Item Name: Crosstube Turning Detail

DART AEROSPACE LTD		Work Order:	85985
Description: Crosstube Assembly (205/212/412 High Fwd)		Part Number:	D212-664-141
Inspection Dwg: D212-664-141 Rev: D		Page 1 of 2

DRAWING NO. D212-664-141	TITLE XTUBE ASSY (205/212/412 HI FWD)	REV. D	DART AEROSPACE LTD ENGINEERING ORDER		D.E.O. NO. D212-664-141-D-1	SHEET NO. SHEET 1 OF 2	SCALE NTS
DRAWN	CHECKED	MFG. APPR.	APPROVED	DE APPR.			
DATE 11.04.07	DATE 11.04.11	DATE 11.04.12	DATE 11/04/12	DATE 11.04.12

DRAWING NO. D212-664-141	TITLE CROSSTUBE ASS'Y (205 HI FWD)	REV. D	DART AEROSPACE LTD ENGINEERING ORDER	D.E.O. NO. D212-664-141-D-2	SHEET NO. SHEET 1 OF 1	SCALE NTS
DRAWN <i>UP</i>	CHECKED <i>ASS</i>	MFG. APPR. <i>AB</i>	APPROVED <i>MD</i>	DE APPR. <i>TH</i>		
DATE 11.07.15	DATE 11.07.20	DATE 11.07.21	DATE 11/07/21	DATE 11.07.21

**D212-664-141/-141B
ASSEMBLY DETAIL**

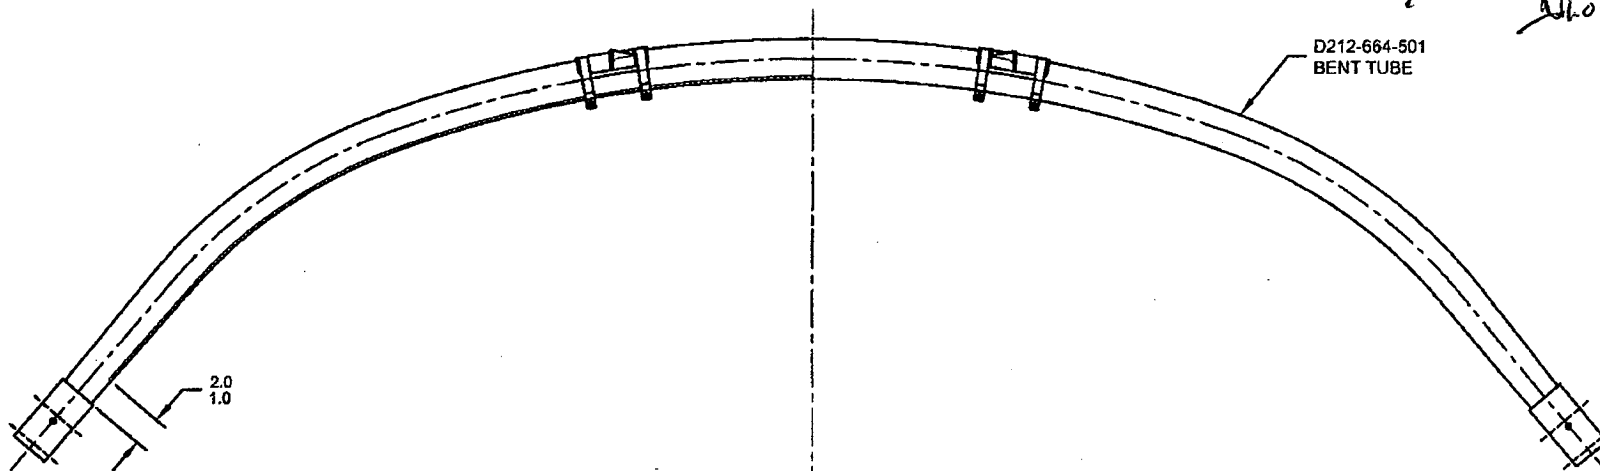
PURPOSE:
ADD AN INSPECTION WINDOW TO UNDERSIDE OF CROSSTUBE.

- 2) FINISH: CHEMICAL CONVERSION COAT PER DART QSI 005 4.1
PRIME INSIDE AND OUTSIDE PER DART QSI 005 4.2
MASK UNDERSIDE OF CROSSTUBE AS SHOWN (HATCHED AREA) AND
PAINT OUTSIDE PER DART QSI 005 4.2
REMOVE MASKING AND APPLY CLEAR COAT

- 2) FINISH: CHEMICAL CONVERSION COAT PER DART QSI 005 4.1
PRIME INSIDE AND OUTSIDE PER DART QSI 005 4.2
PAINT OUTSIDE PER DART QSI 005 4.2

MASK AREA PRIOR TO PAINTING.
REMOVE MASKING AFTER PAINT
AND APPLY CLEAR COAT
